BLOOMINGTON HISTORIC PRESERVATION COMMISSION
Showers City Hall
McCloskey Room
Thursday June 27, 2013
4:30 P.M.
AGENDA

PARTIAL DEMOLITION

721 South Lincoln

6-18-13
303 East 10th Street
Cottage Grove Survey Area
Owner Tariq Khan

Building (Greenhouse) Plan

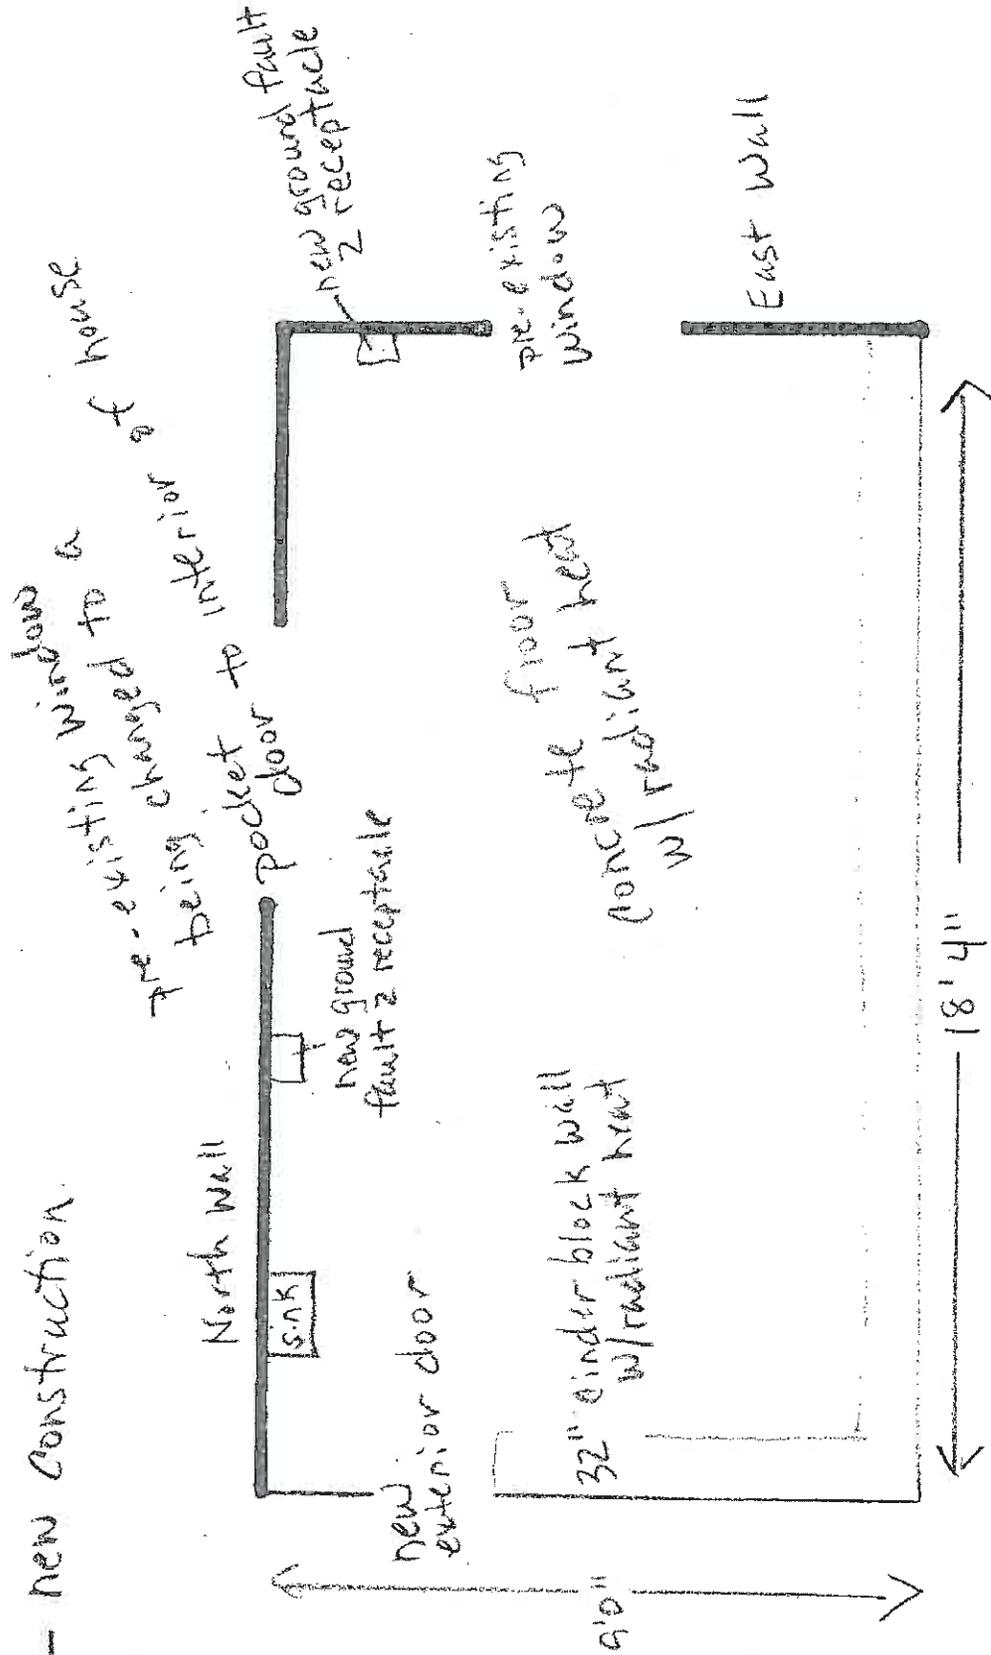
The structure will be 9' wide and 18' 4" deep, starting 11' 3" behind the front facade of the building measured from the back of the porch. It will fill out the ell between the addition and the house proper.

elements are anodized aluminum frame with glass panes. Plans show a single door to the exterior on the north side of the feature and a window widened to make a pocket door on the south side of the house wall. The structure will be tucked beneath the eaves of the building, and also obscured by landscaping.

The existing lot is 44' x 132'. Placement of the greenhouse will require a 1'9" setback variance. Plans will only impact the one original window. The paired window on the south side will not be covered. The area is also masked by a 4' opaque fence belonging to the adjacent neighbor.

Site Plan

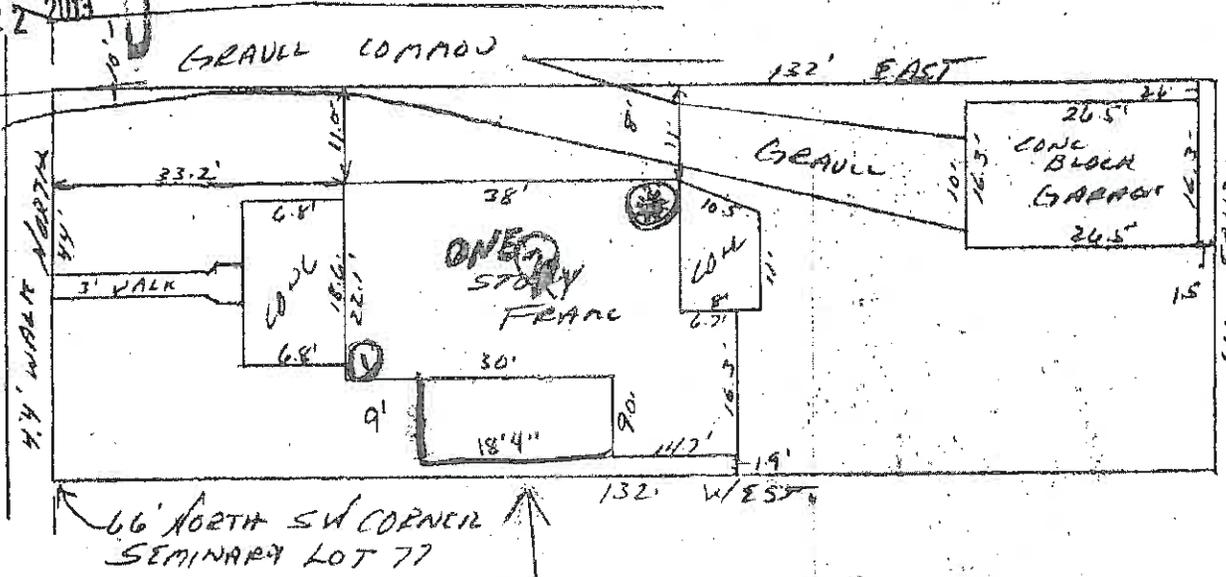
- (A) proposed Greenhouse new walls highlighted
- (B) See notations on Building Plan for explanation of * (1) (2)

303 E. 10TH
 TARIQ KHAN
 812-369-1661
 UPSTAIRS

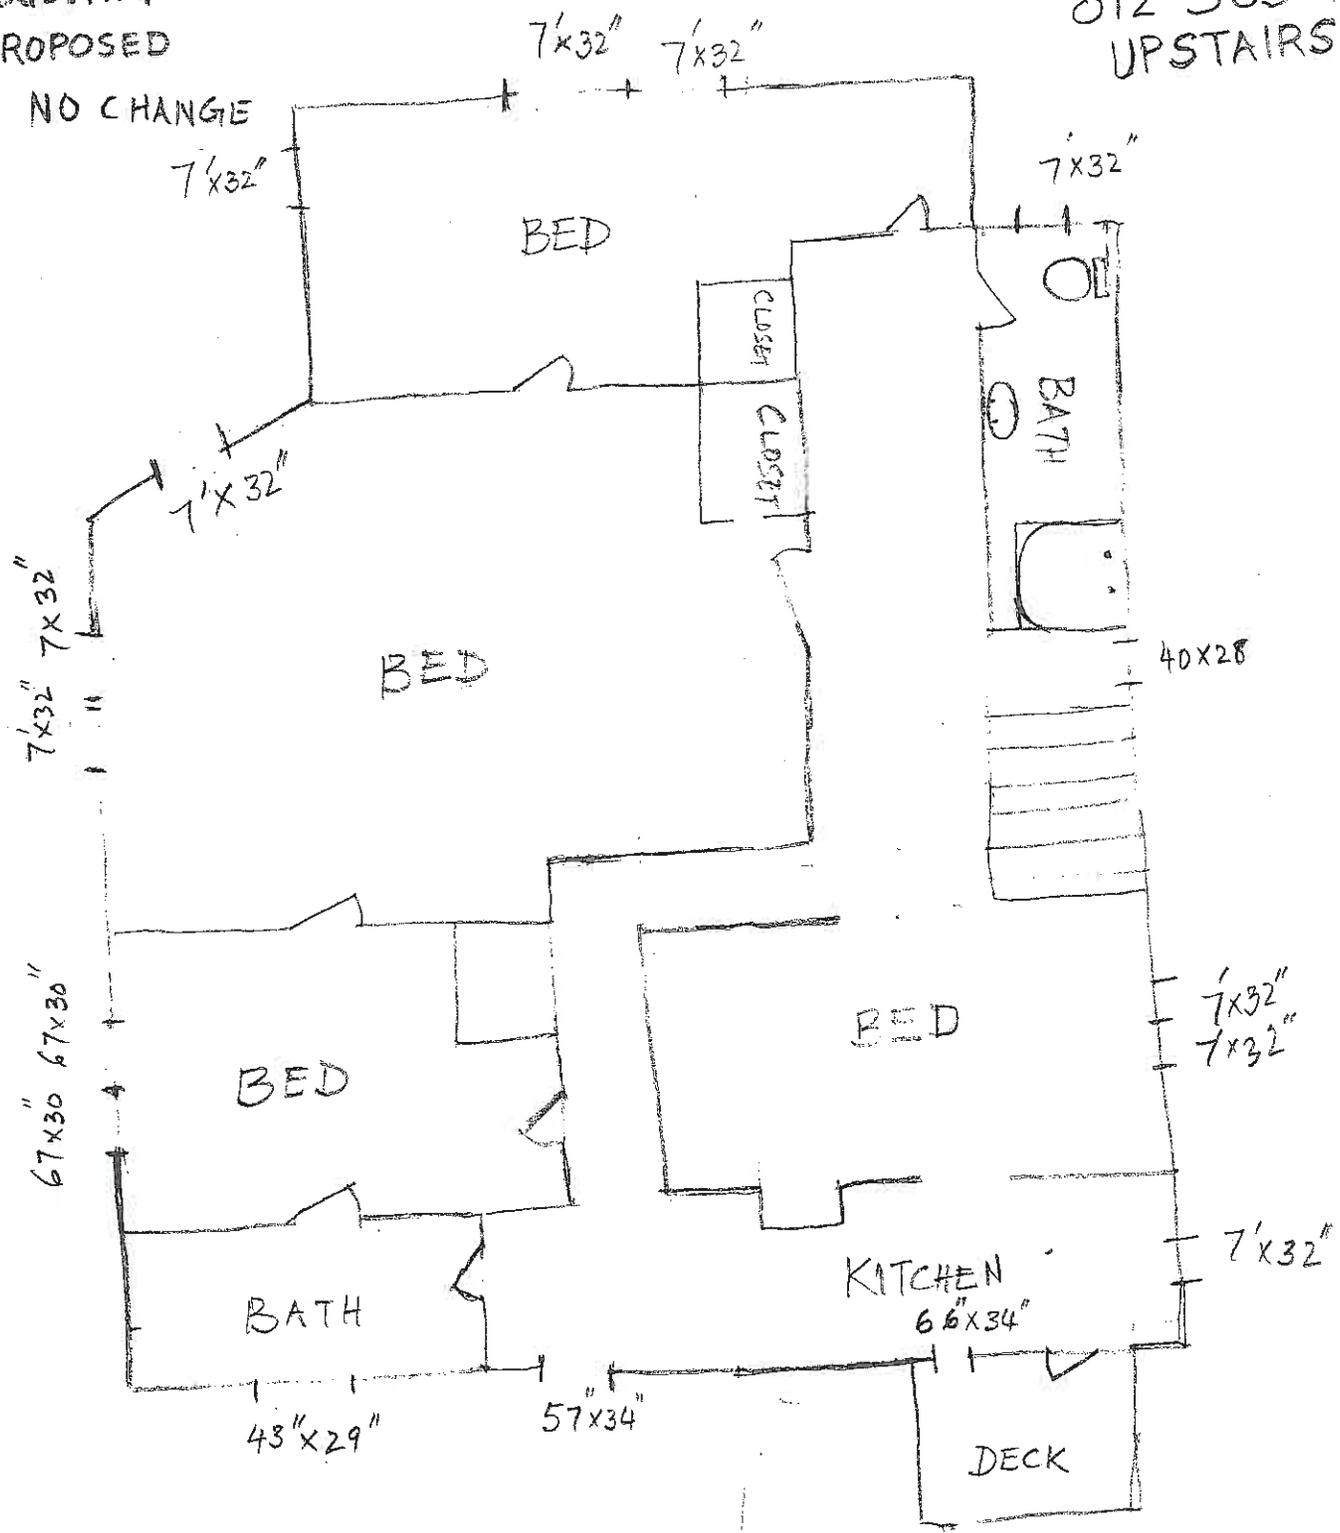
proposed resizing of windows, and frame replacement. In order to assess the impact either a modified photograph showing changes to the exterior or a drawing is required. The vinyl replacement windows will be resized within the openings. In most cases the windows will be observably reduced in the vertical direction. After having removed the existing windows, the owner realized that vinyl windows would not support the large original openings, and the size reduction is partially for that reason. The double hung format will remain the same. The owner does not intend to put siding on the house.

The owner included a window schedule to show the existing and new dimensions of the windows and also a photo-shopped picture of the house depicting the completed work

Please note that some of the original windows were very tall and very close to the ground and in my opinion were unsafe as well as inefficient, partly due to missing headers. Consequently I have proposed to make some of the windows a little smaller. For instance window in the front of the house was reduced from 7' x 32" to 62" x 28" (double hung, vinyl energy efficient windows). For more details please refer the attached plan document.
